Drawing Title
COVER SHEET

PROPOSED MIXED USE DEVELOPMENT

47-50 THE ESPLANADE ETTALONG BEACH

S75W SUBMISSION

Drawing Title
SITE PLAN AND SITE ANALYSIS

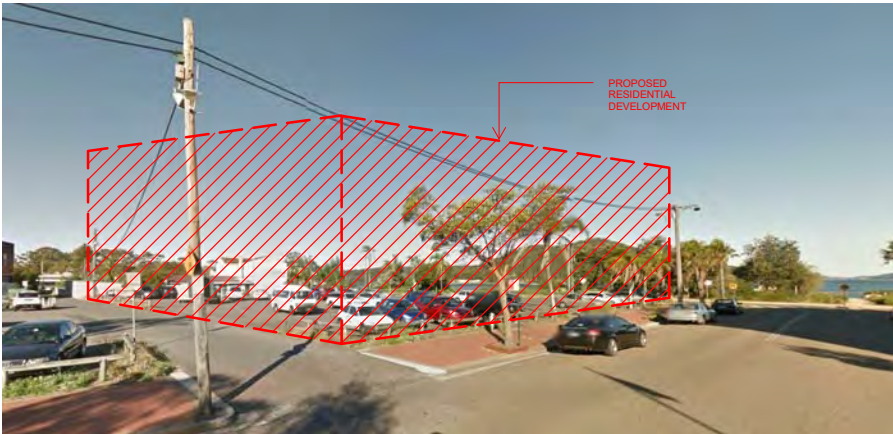
S75W AMENDMENTS:
SIGHTLINE SECTION MARKERS ADDED

47-50 THE ESPLANADE ETTALONG BEACH
Drawing Title
BASEMENT FLOOR PLAN

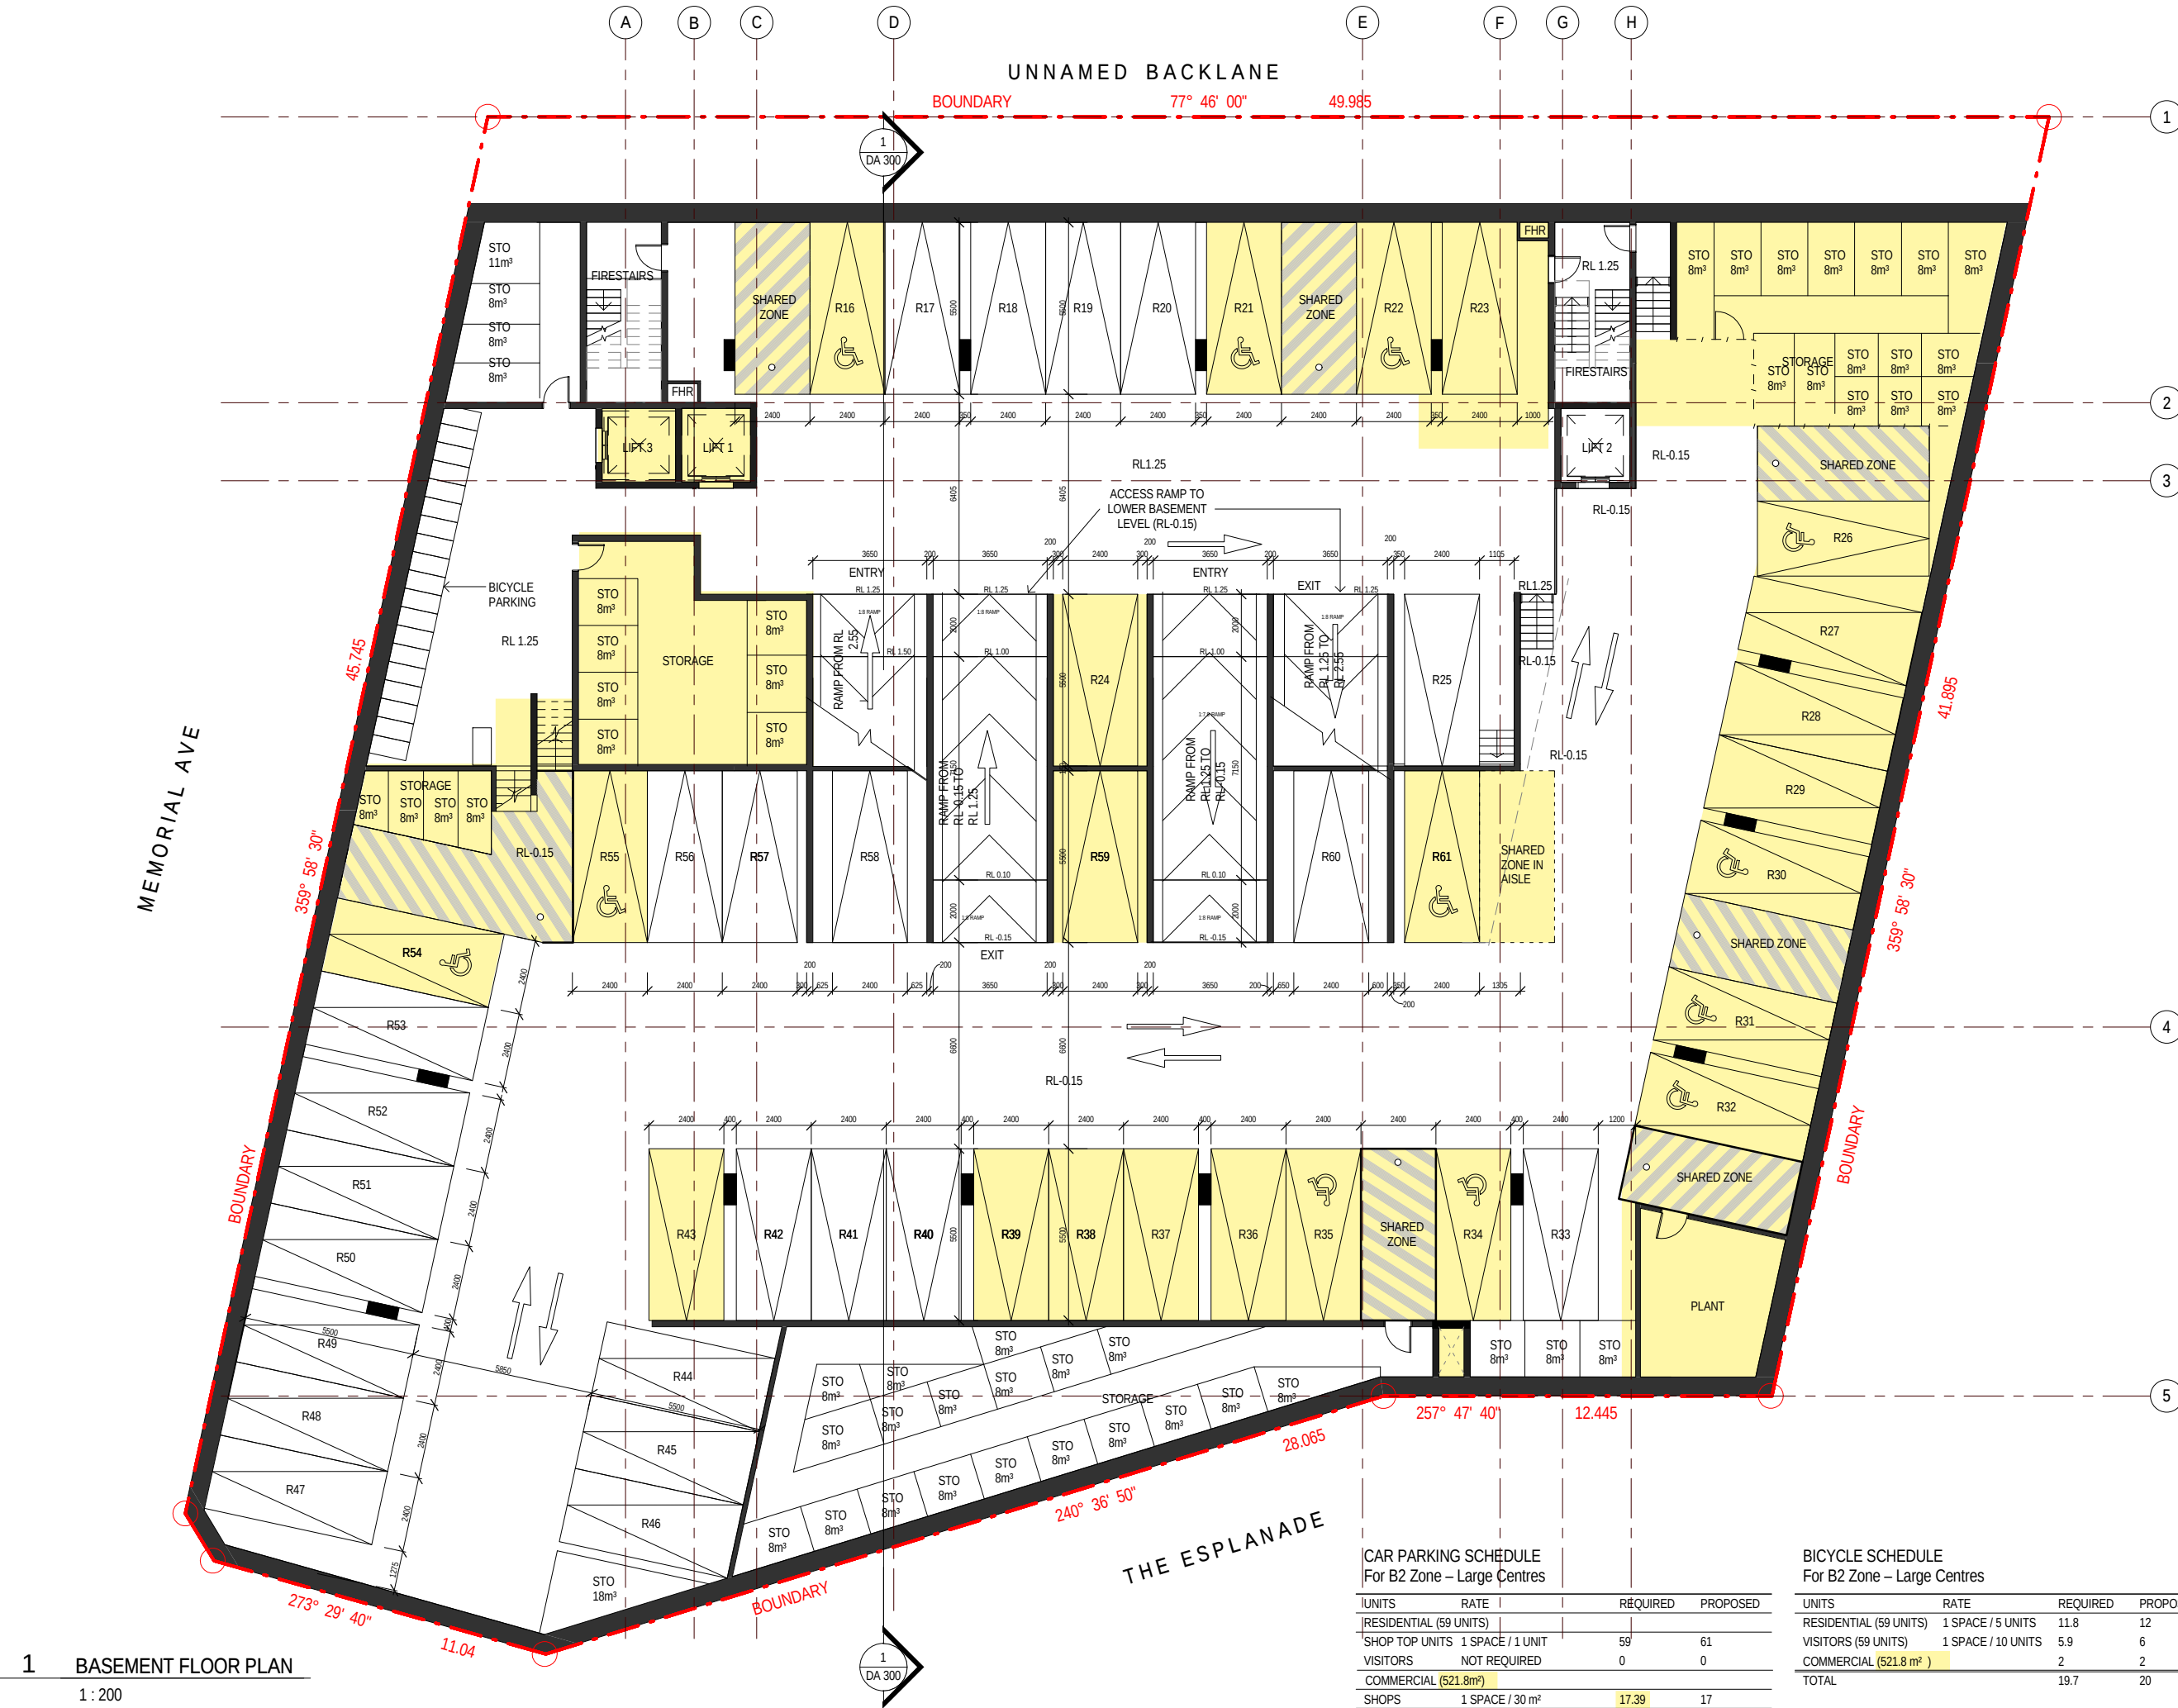
- STORAGE AREAS REVISED
- LIFT03 ADDED / LIFT 01 RELOCATED
- CARPARK LAYOUT REVISED
- CARPARK SCHEDULE REVISED
- GARBAGE ROOM ON BASEMENT REMOVED
- SECTION LINE RELOCATED

1 BASEMENT FLOOR PLAN
1 : 200

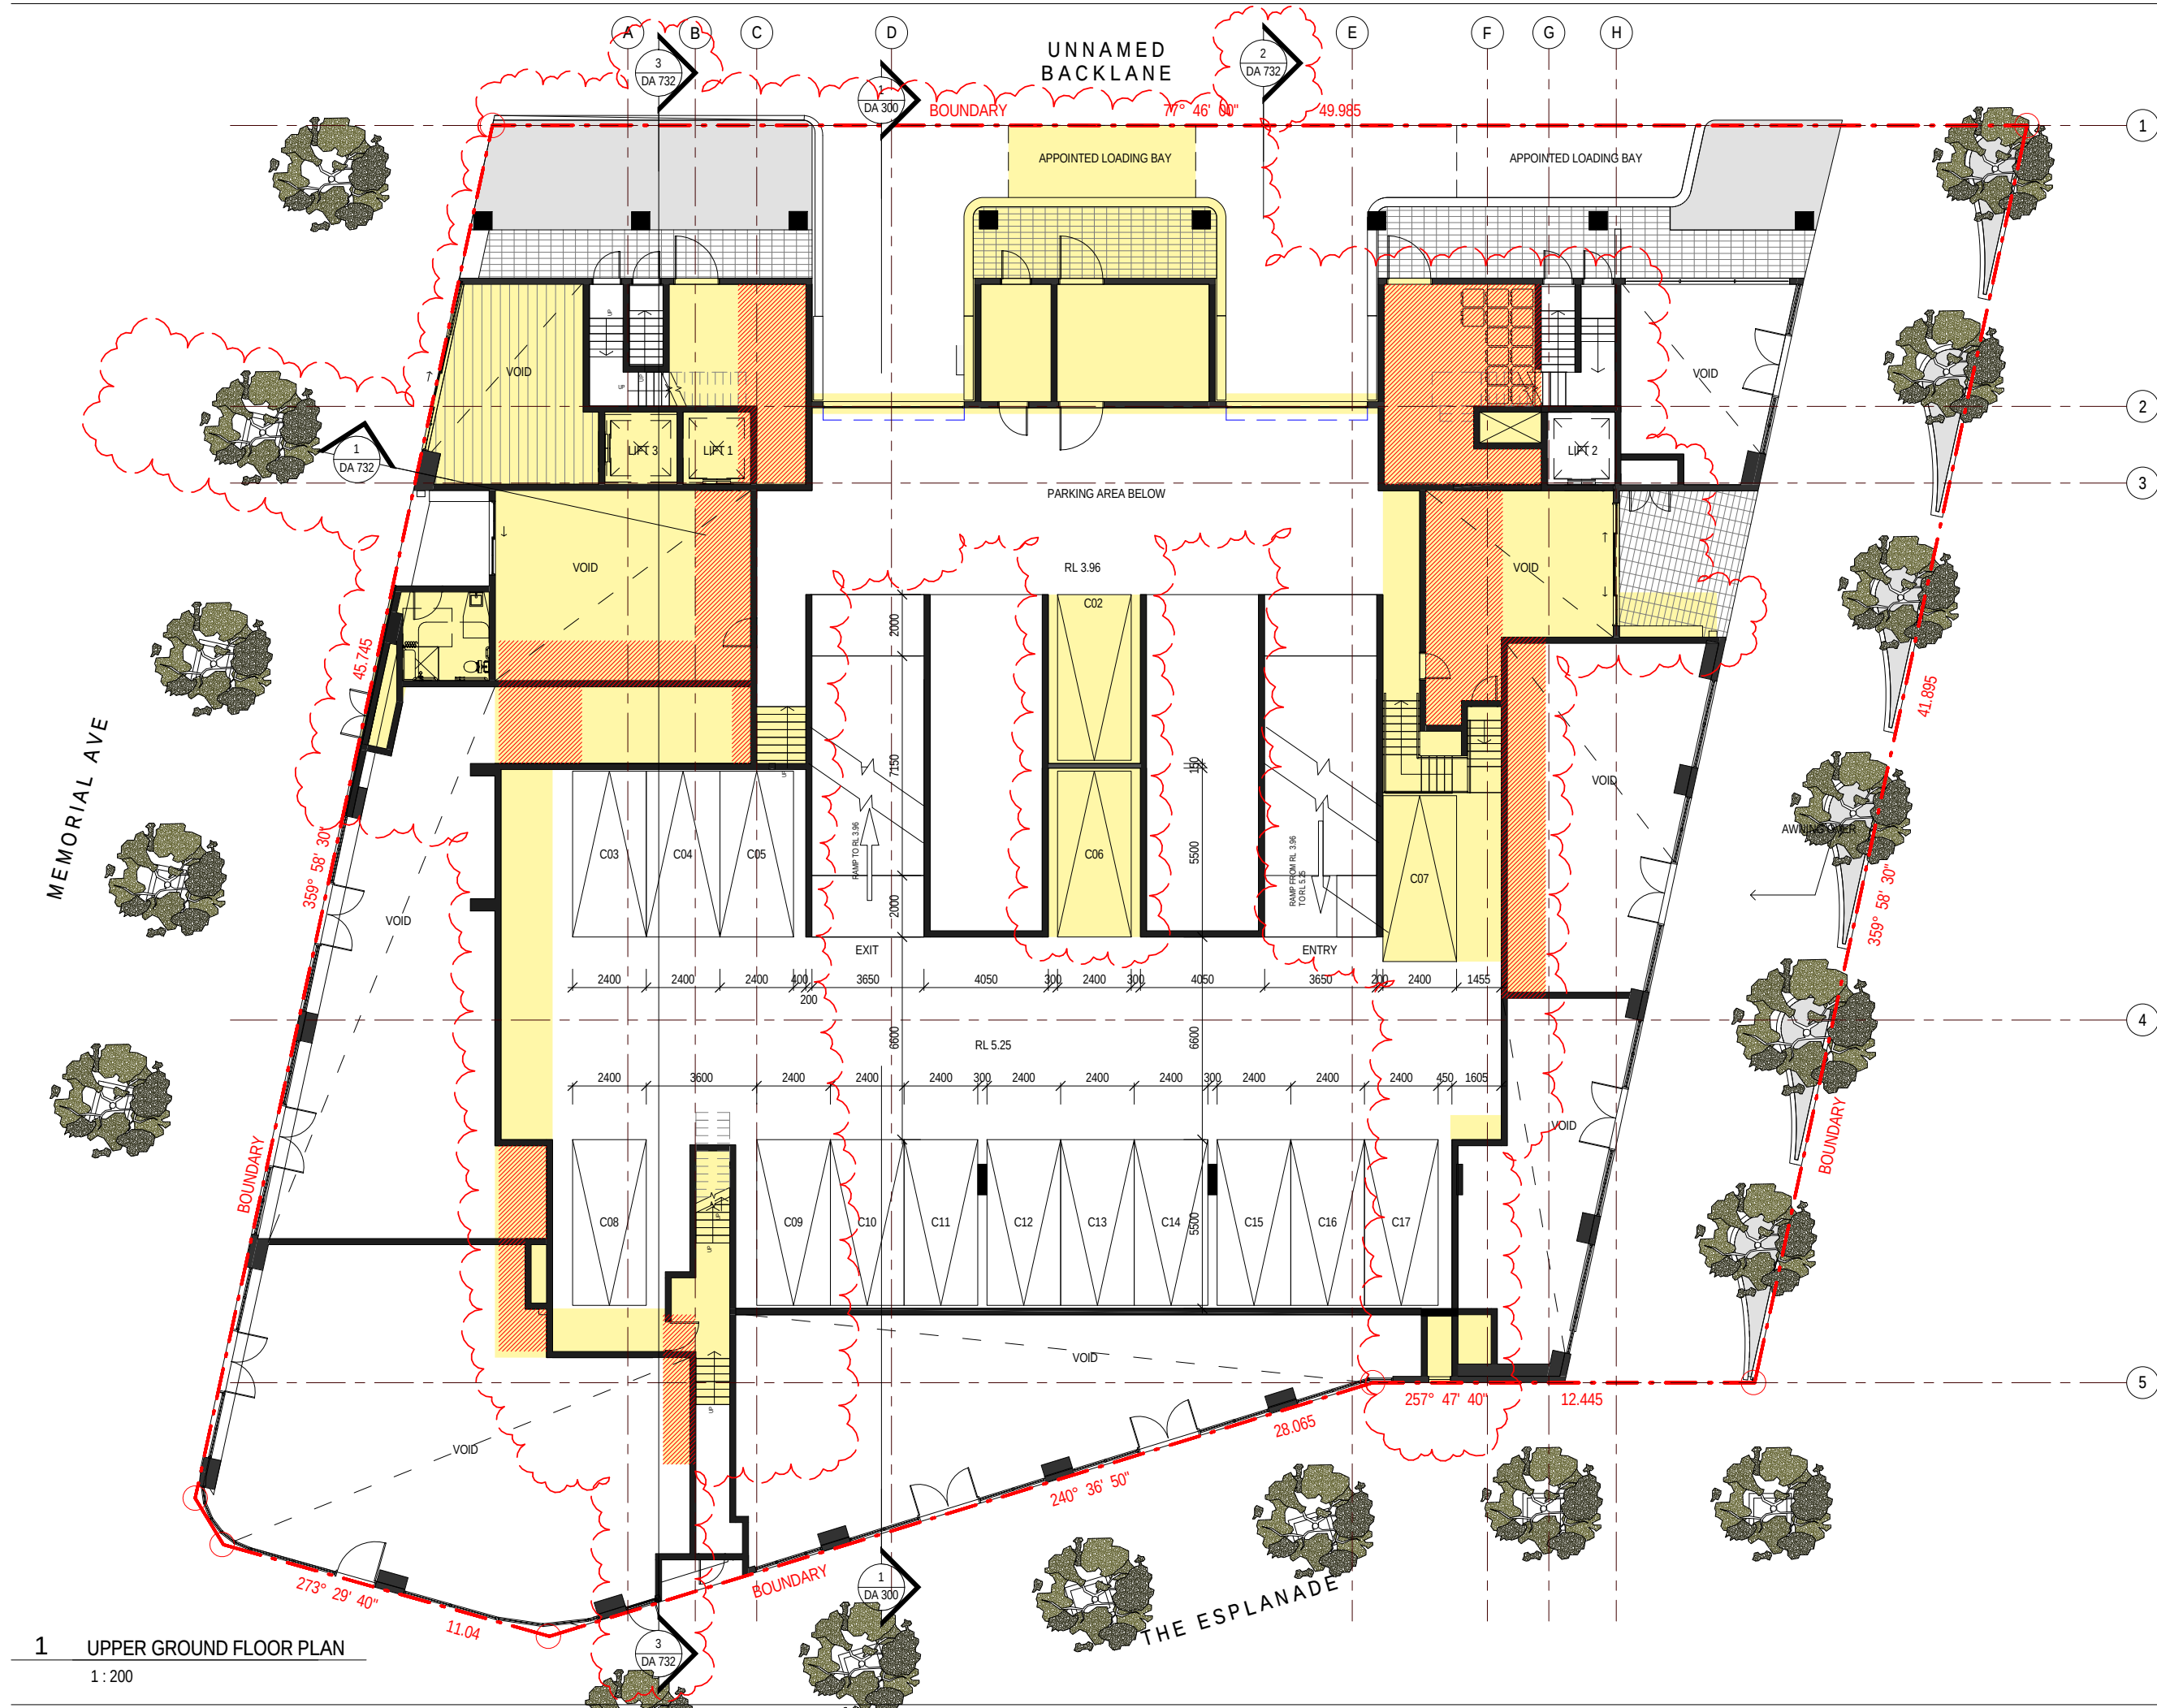
- RETAIL 1 CONVERTED TO PRIVATE LOBBY
- LIFT03 ADDED / LIFT01 RELOCATED
- CARPARK LAYOUT REVISED
- GARBAGE ROOMS REVISED / CARPARK EXHAUST REVISED
- COMMERCIAL AREAS REVISED
- CARPARK SCHEDULE REVISED
- ACCESSIBLE TOILET REVISED
- SECTION LINE RELOCATED
- MAILBOXES & INTERCOM ADDED
